CITY OF STAR

LAND USE STAFF REPORT

FILE(S) #: FP-24-10, Final Plat, Cranefield Subdivision Phase 3

Cranefield Subdivision No. 3

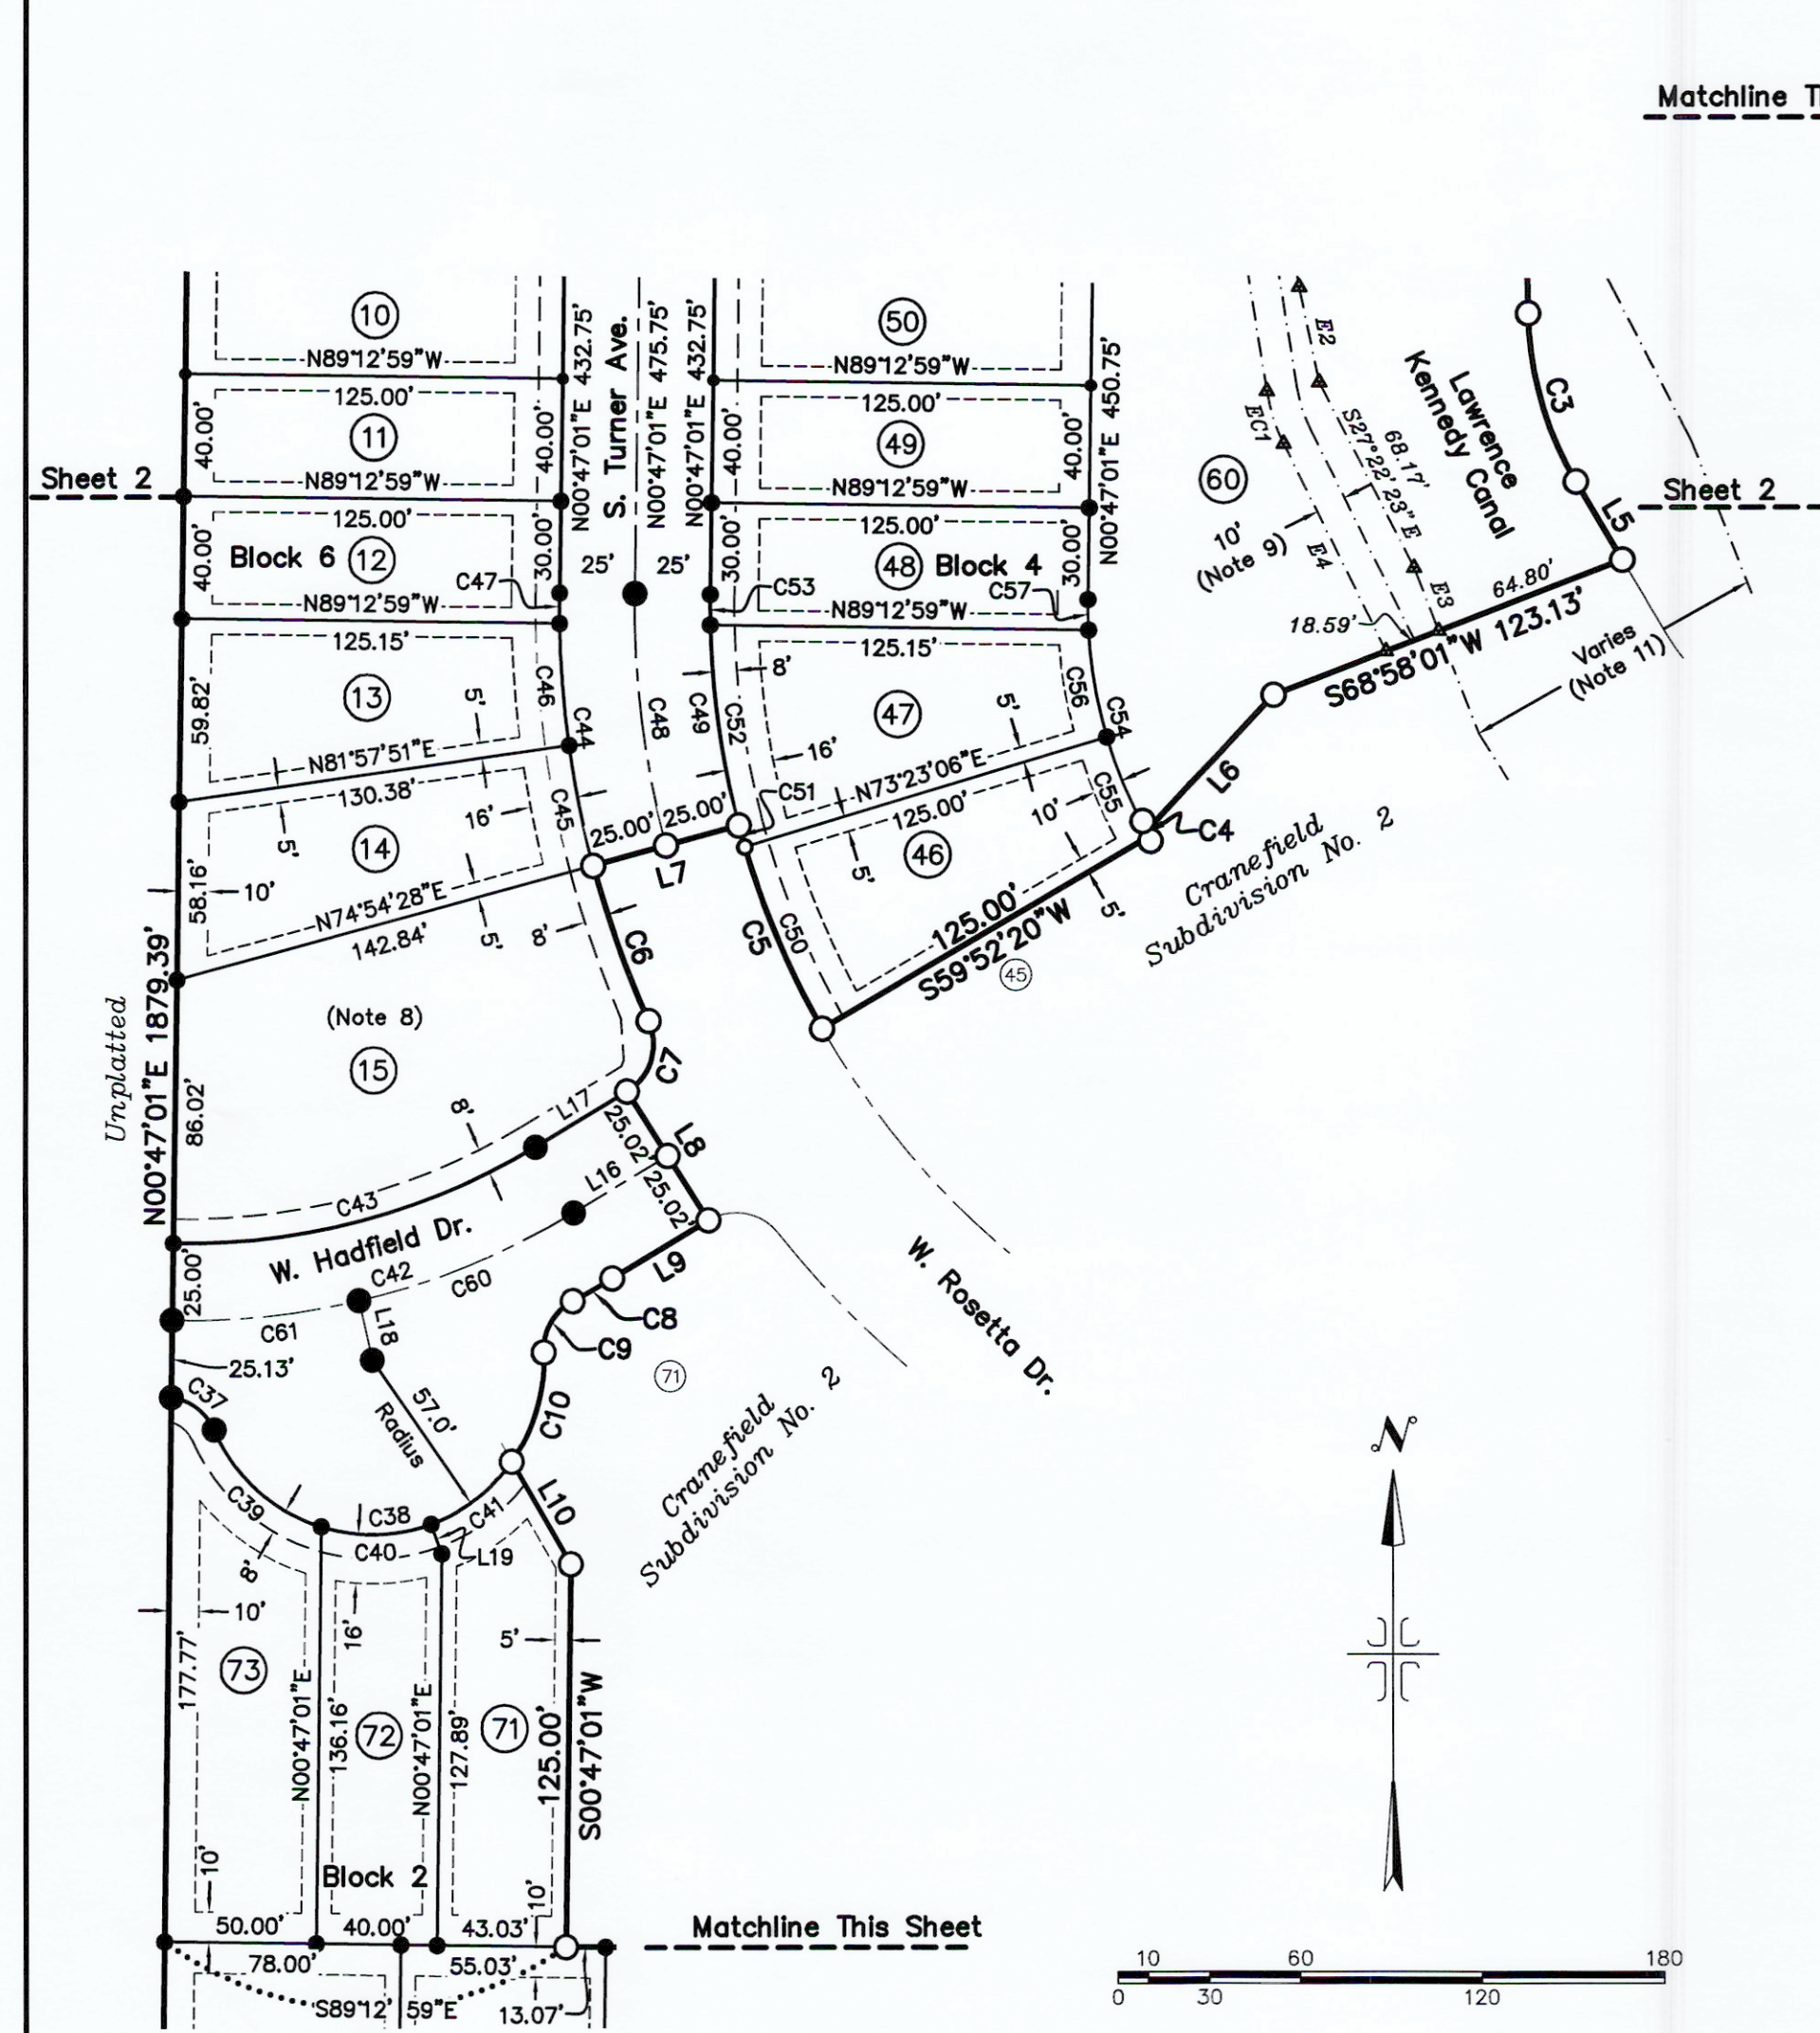
The submitted Final Plat for Phase 3 includes flag lots on Lots 74, 82, 83, and 106, Block 2. This layout does not match the approved Preliminary Plat and Star Unified Development Code, as flag lots are not permitted unless specifically approved by the Fire District. This same issue happened in Phase 2 of the development. Staff is requiring the same conditions be placed on Phase 3 per the Star Fire District requirements as outlined in the attached review letter for Phase 3. Per the letter issued by Star Fire dated October 9, 2024, the future homes on these four flag lots shall be required to install fire sprinklers in accordance with Fire District requirements. In addition, the driveways located on these flag lots shall be separated from each other using landscape strips, as common driveways are not permitted, per the UDC. This will be a condition of approval.

- 1. Prior to approval of the Final Plat by Council, the applicant shall provide Staff with a letter acknowledging the Star Fire District requirements for Lots 74, 82, 83, and 106, Block 2. This shall include the requirements for fire sprinklers in the future homes on these specific lots in addition to the landscape buffers along the private driveways of each of these lots.**
